**COUNTY OF SAN MATEO  
PLANNING AND BUILDING DEPARTMENT**

**SUBJECT:** EXCECUTIVE SUMMARY: Consideration of a Design Review Permit, Coastal Development Permit, Non-Conforming Use Permit, and Off-Street Parking Exception to allow construction of a new 2,051 sq. ft., three-story single-family residence on a legal non-conforming parcel in the unincorporated Miramar area of San Mateo County. The use permit is required to allow a 5-foot left side setback where 10 feet is required, and to allow development on a 4,400 sq. ft. parcel, where 10,000 sq. ft. is required by the S-94 Zoning District. The project is not appealable to the California Coastal Commission.

County File Number: PLN 2018-00490 (Mithal)

**NEW MITHAL RESIDENCE**  
**MAGELLAN AVENUE**  
 HALF MOON BAY, CA

**FIRST FLOOR PLAN**  
 (SEE SHEET AR-0 FOR PLANTING PLAN)  
 1/4" = 1'-0"

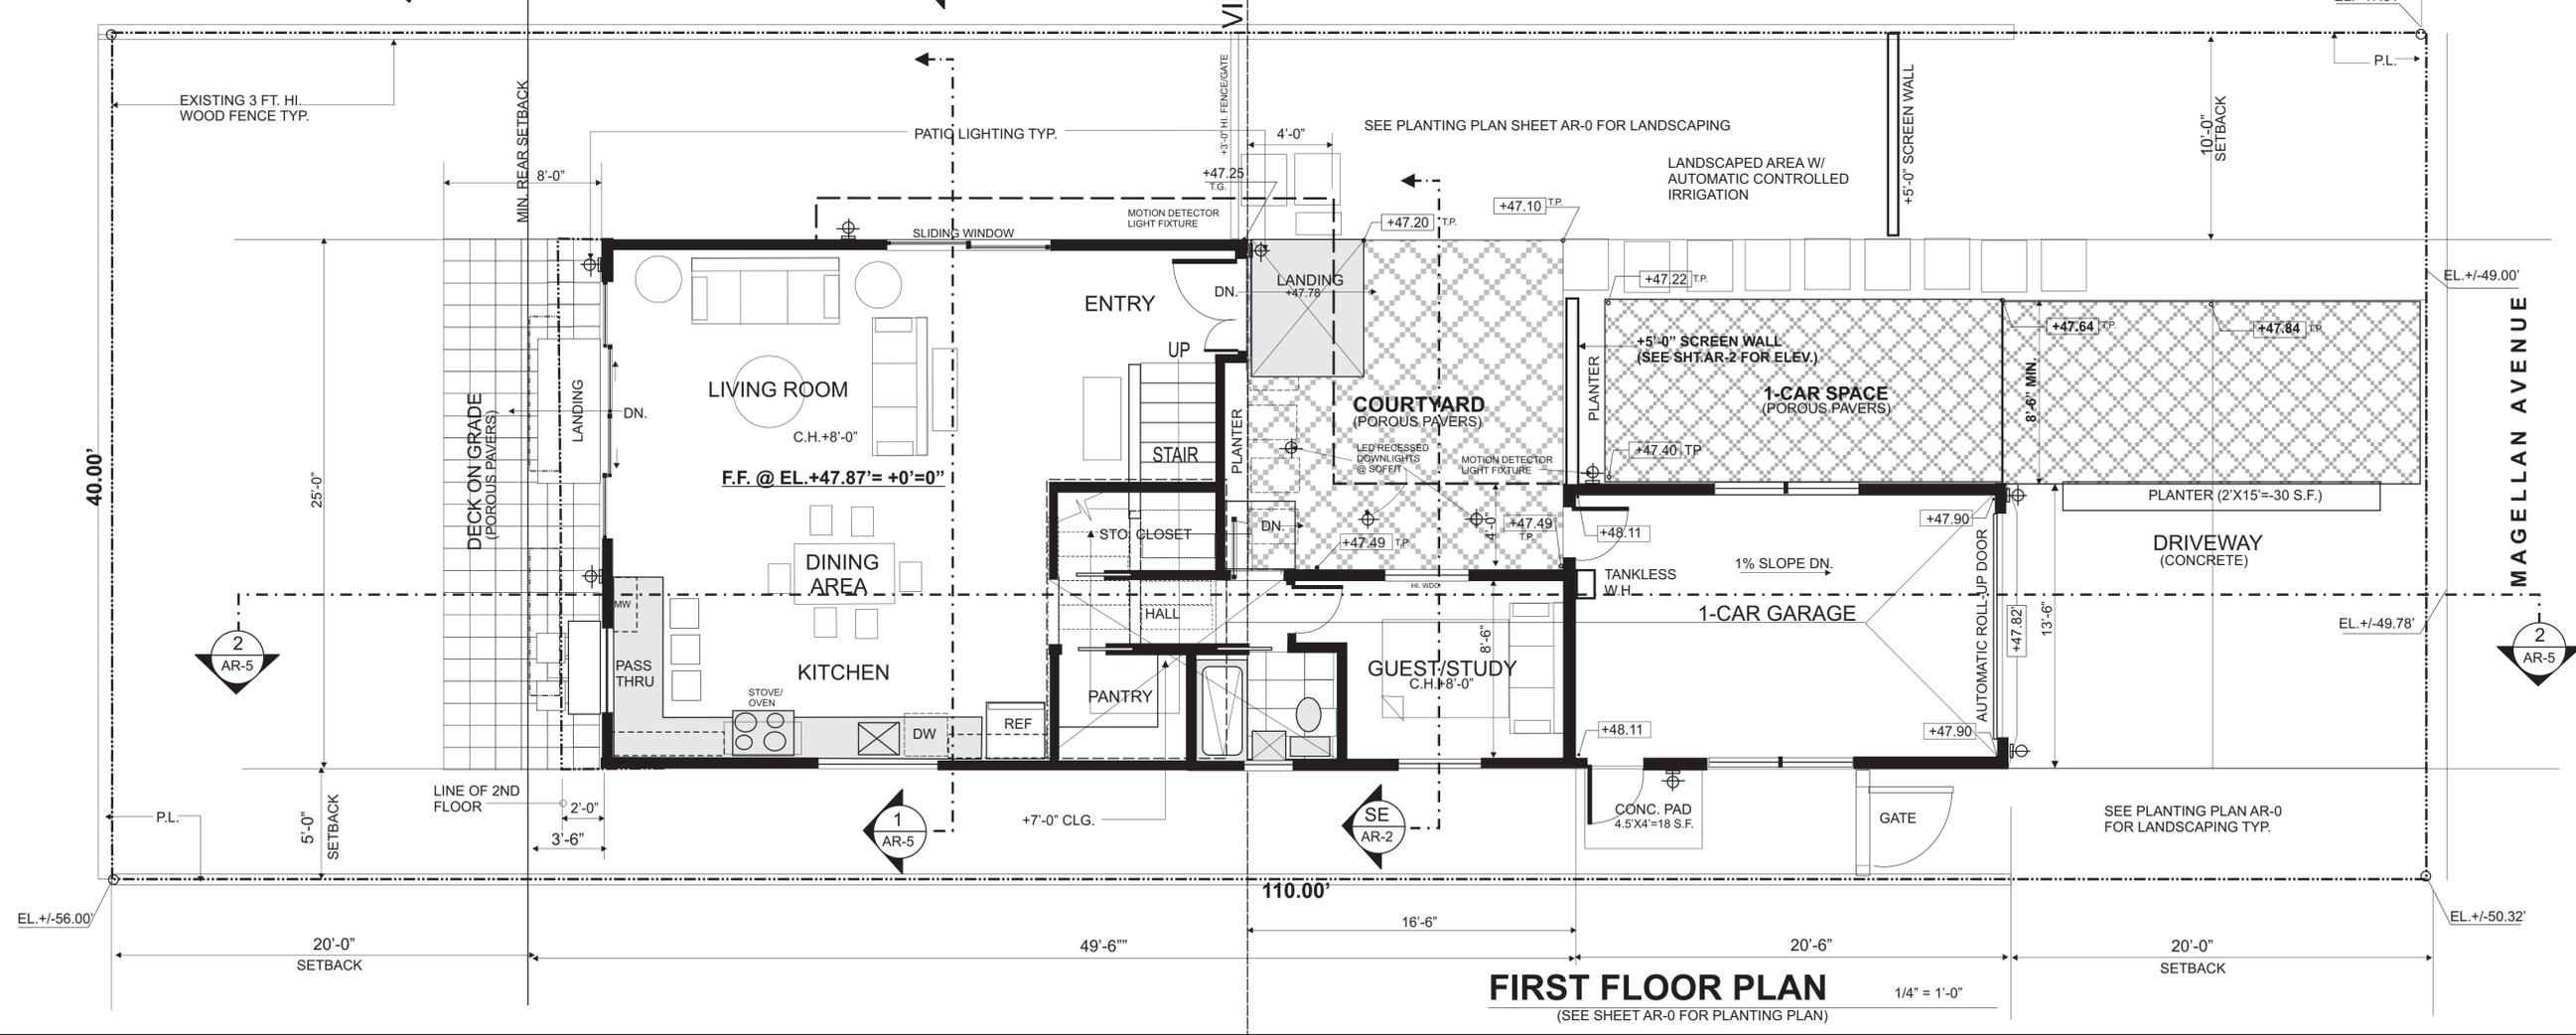
- c. Remove 2 exterior lights on ground level on either side of large window on west side of building.
- d. Remove exterior motion detector light on west side of building on first floor plan.

**WEST ELEVATION** 1/4"=1'-0"

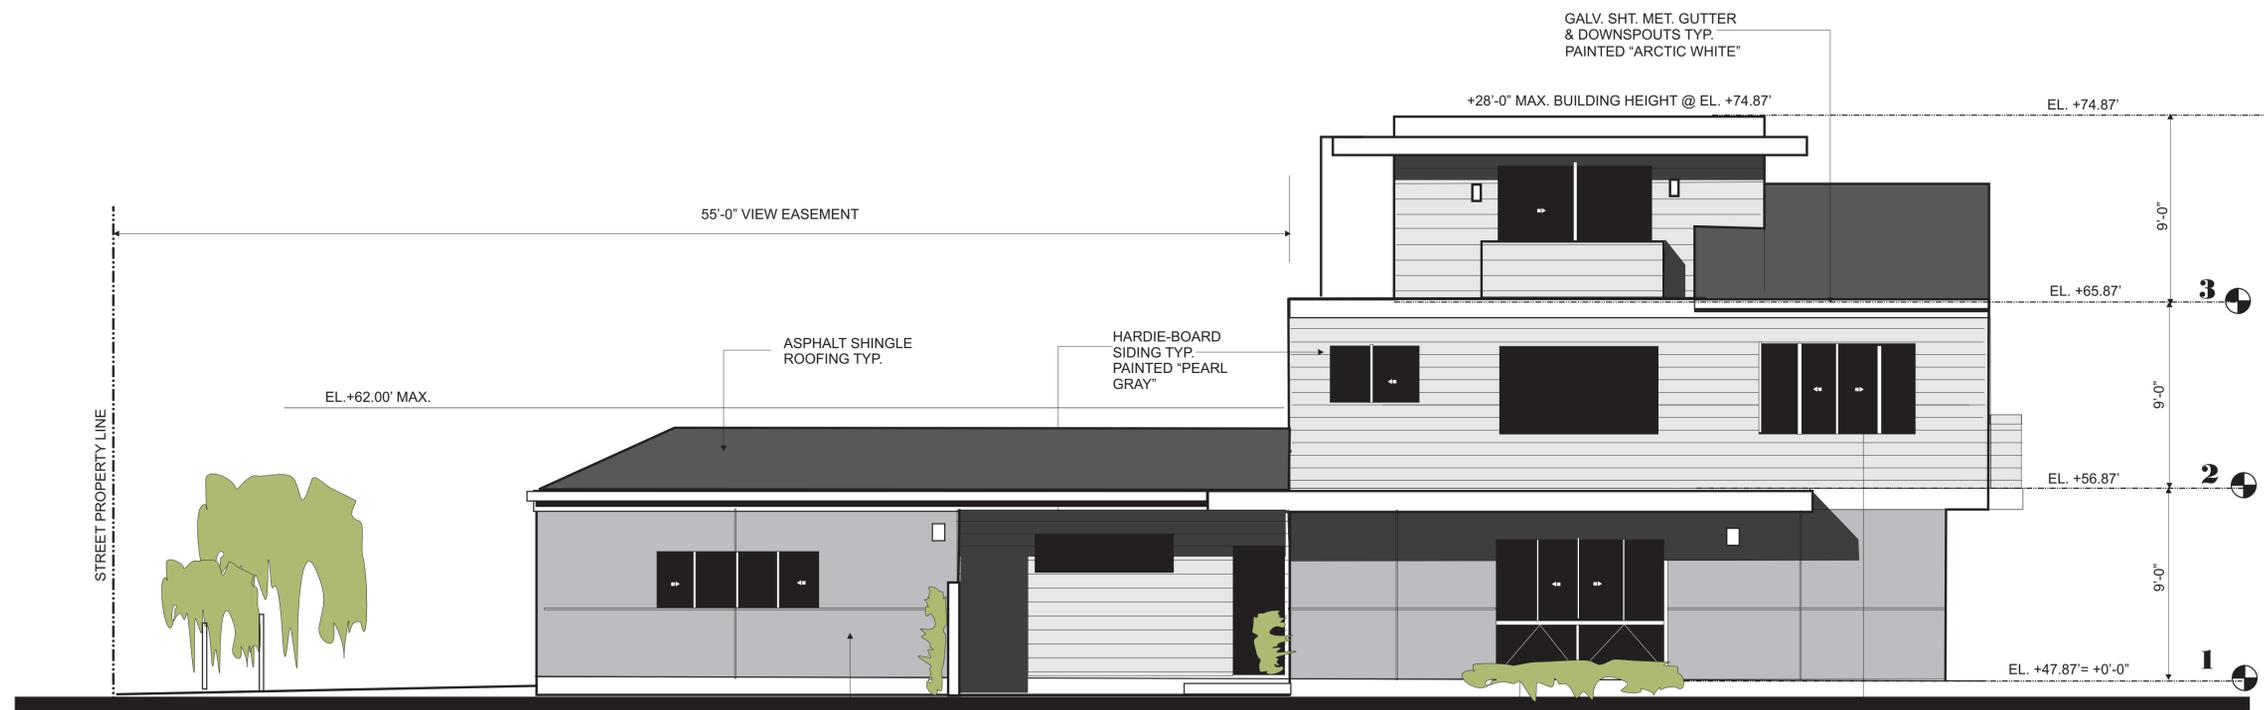
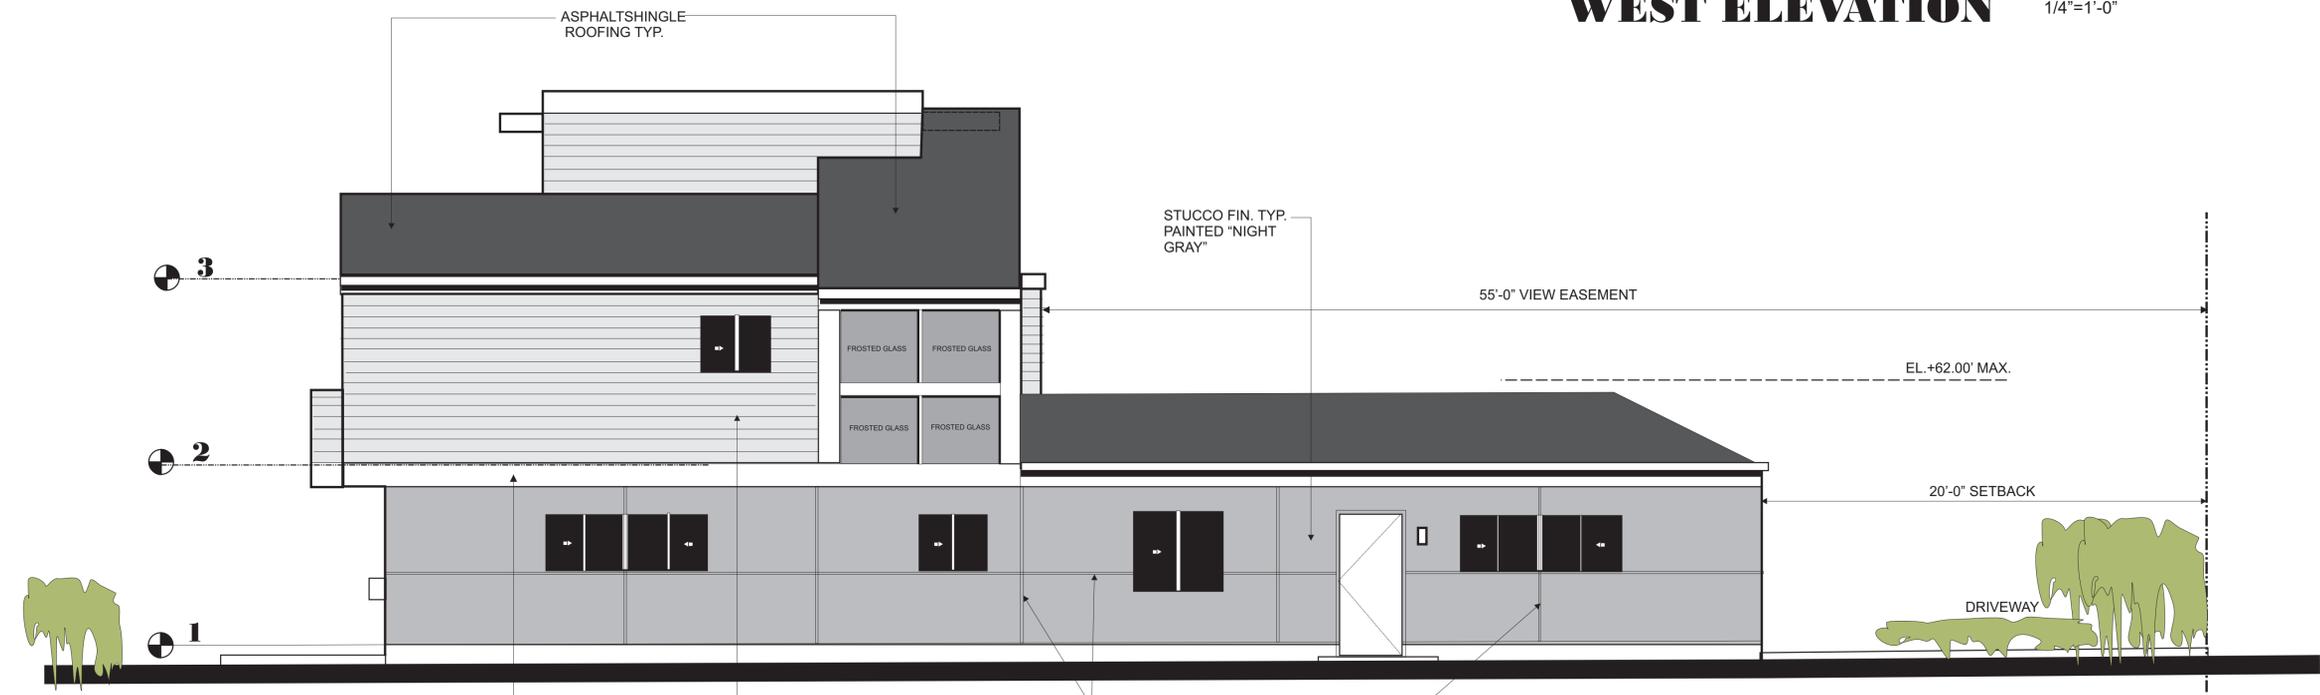
- b. To break up stucco wall treatment, add a vertical reveal line in stucco wall on west side to the left of living room window. Also, add a horizontal reveal line at 4 feet high, wrapping the building.

# PLANTING LAYOUT

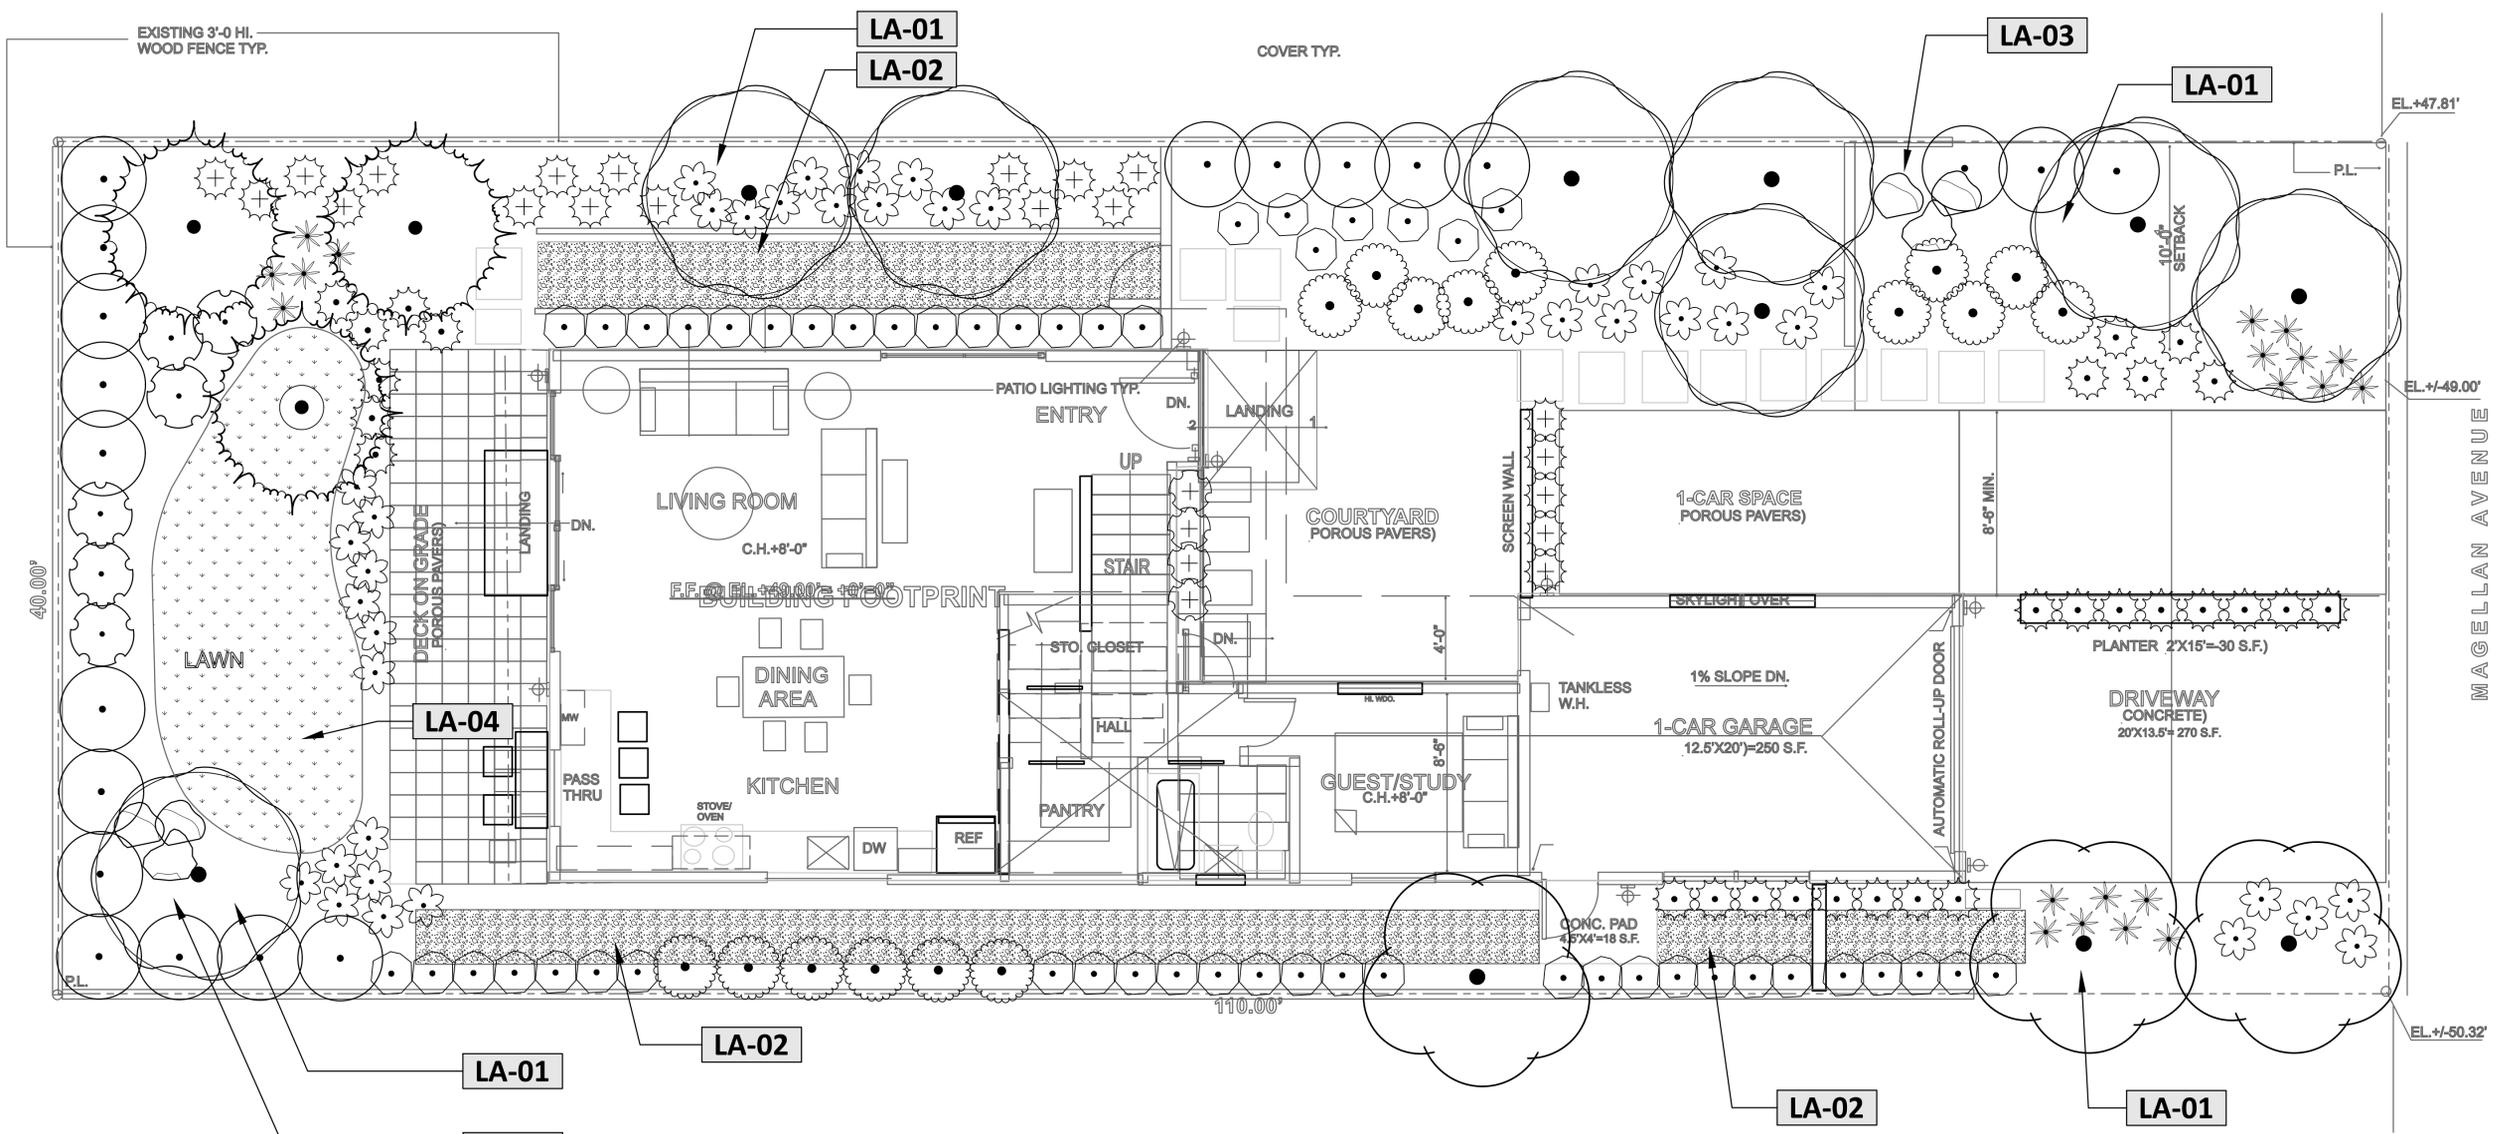
- e. Consult a licensed landscape designer and revise plans to reflect the following:
  - (1) Use an alternate, less linear design for the shrubs that are shown on the plan.

- (2) Leave trees as called out on the plan.
  - (3) Remove invasive species, *Stipa* and *Ipomea*, from the plant list and consider substitute grasses and ivy (e.g., *Calamagrostis Folios*, *Festuca Californica* *Leymus* and *Ficus Pumila*).
